Revision of Manuscript Number: IEEE-TPWRS-01391-2021, version 1 January 3, 2022
Journal: IEEE Transactions on Power Systems
Author: Abhishek Halder, Kenneth F. Caluya, Pegah Ojaghi, Xinbo Geng

Response to decision:

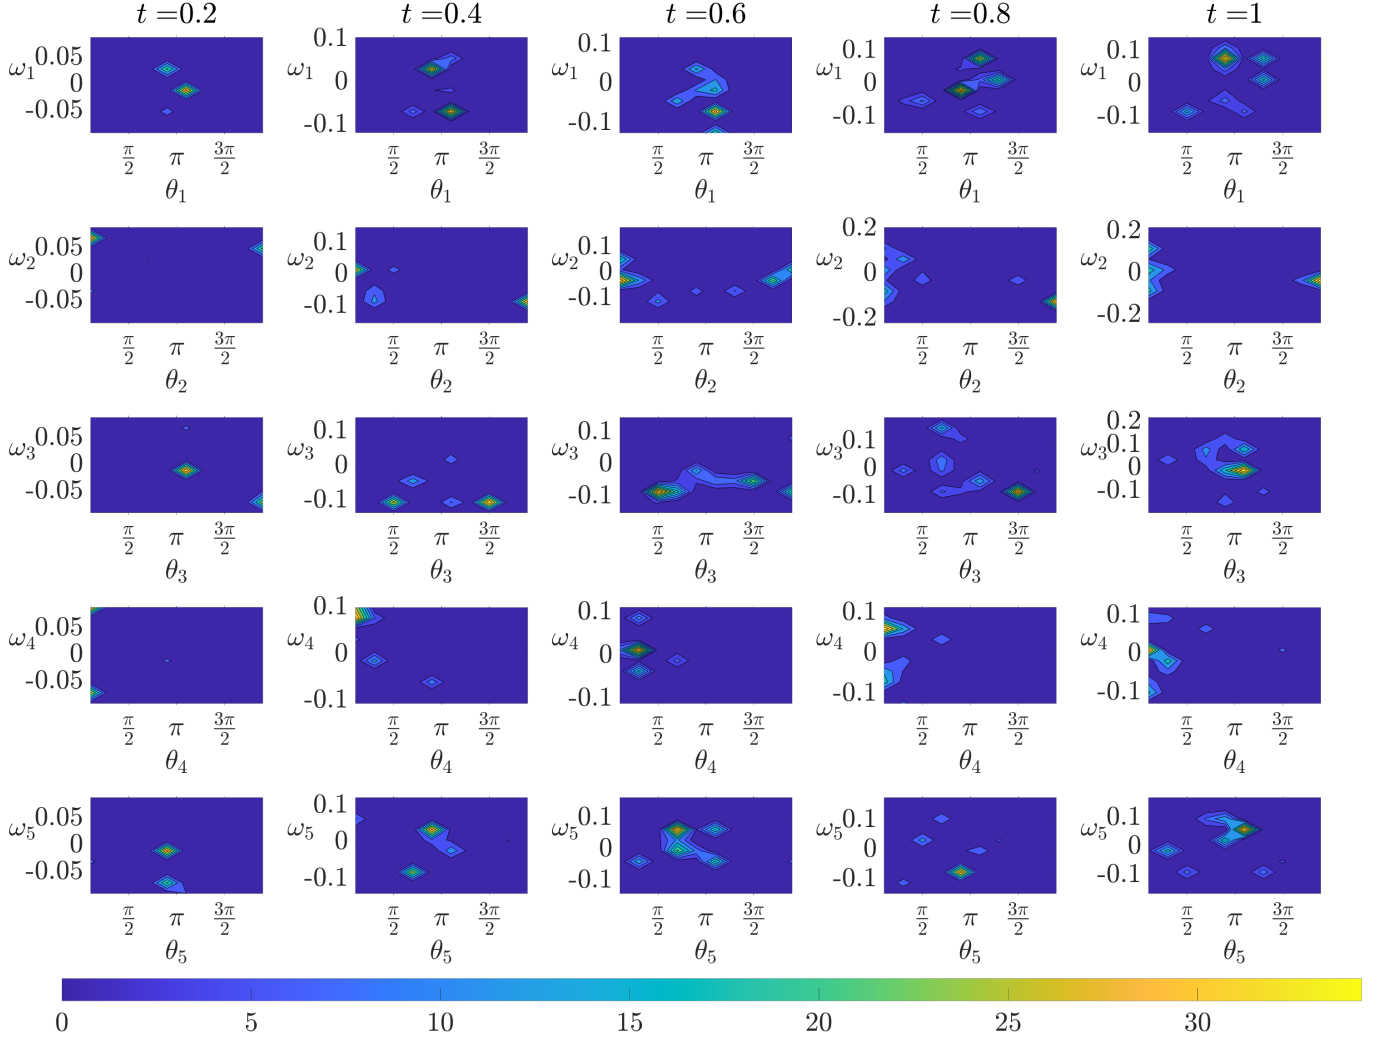
Figures 5 and 6 are unreadable.

Response: Thanks for this comment. In the previous version, the strict 10 page limit enforced small figure sizes. In the revised manuscript, Figures 5 and 6 are made larger. Also, the Fig. 6 in the revised manuscript shows the transient (θ_i, ω_i) bivariate marginals for all the five generators in Case II; the previous version showed the same only for the generator 4 (bus 6). We believe these changes have improved clarity.

Regarding the style of plots, we had considered plotting the bivariate marginals as planar contour plots (as in Fig. 1 in this rebuttal document) but decided against it because of the following two reasons.

First, in our opinion, this kind of plot is scientifically misleading as they hide the fact that these bivariate marginal PDFs are not really supported on the plane, or the subsets thereof, but instead have cylindrical supports. Our message that the proposed method explicitly accounts this manifold geometry in the computation, would be missed had we chosen to make the plots as per populist cognitive bias on behalf of the readers. That the planar plots evoke a sense of familiarity cannot be a scientific argument in favor of it.

Second, the planar contour marginal plots require additional mental efforts from the readers to correctly parse the statistical information conveyed. For instance, consider the fourth column, second row subplot in Fig. 1 in this rebuttal document. It is upon the reader to parse that the two high probability regions on the left and right of that subplot are actually referring to the same angular high probability region around $\theta_2 = 0$ rad, thanks to the periodic boundary condition on the angular variable. Our philosophy of technical communication is that the onus is on the authors, not on the readers, to clarify the scientific information as correctly as possible. And yes, we are aware that many papers in the power system literature make plots in the rectangular domain ignoring the manifold nature of the support, which in our experience, continue to add pain to the graduate students and beginning researchers trying to decipher the statistical meaning conveyed in those plots. We prefer ours not be contributing to the accrual of such pain, and instead make plots that depict the variables as they are.
